IEEE 802.11
Wireless Access Methods and Physical Layer Specifications

TITLE: Proposed Text Change for Physical Layer
Service Specifications

DATE: March 6-10th,1995

AUTHOR: Ed Geiger
Apple Computer
One Infinite Loop
Cupertino, CA 95014
edg@apple.com

Figure 8-1 Protocol Reference Model

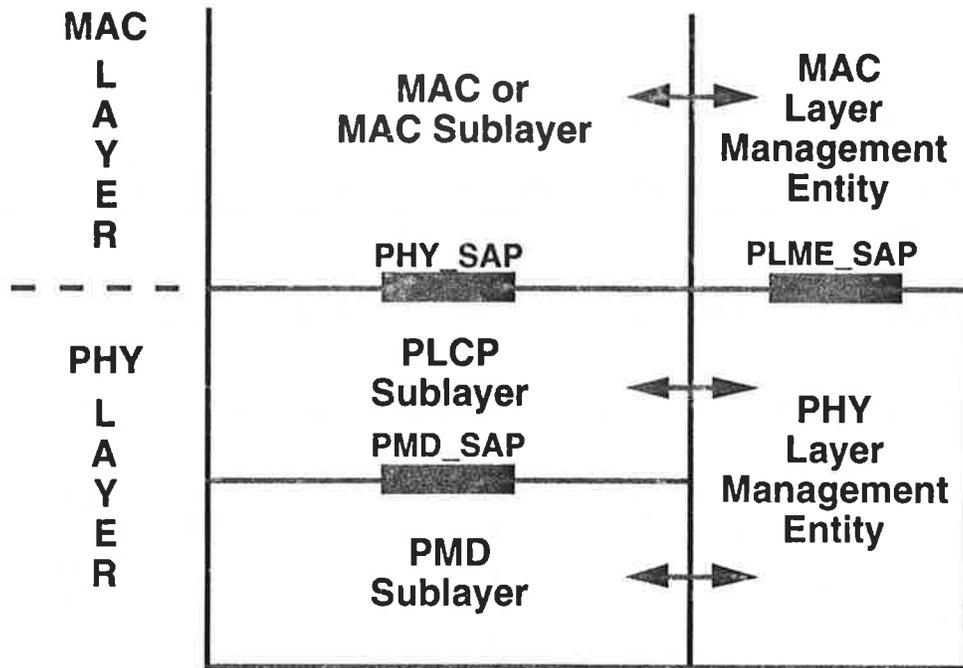
As part of my ballot comments, I agreed to supply new text to address the problems I saw with section 8 of the Draft Standard. I propose that section 8 be replaced all together with this text.

8.2 Physical Layer Functions. The Protocol Reference Model for 802.11's architecture is shown in Figure 8-1. Most physical layer contains three functional entities: the physical medium dependent function, the physical layer convergence function, and the layer management function. Each of these functions is described in detail in the following subsections.

The Physical Layer service is provided to the Media Access Control entity at the node through a Service Access Point (SAP) as shown in Figure 8-1 called the PHY_SAP. A set of primitives might also be defined to describe the interface between the physical layer convergence protocol sublayer and the physical medium dependent sublayer called the PMD_SAP.
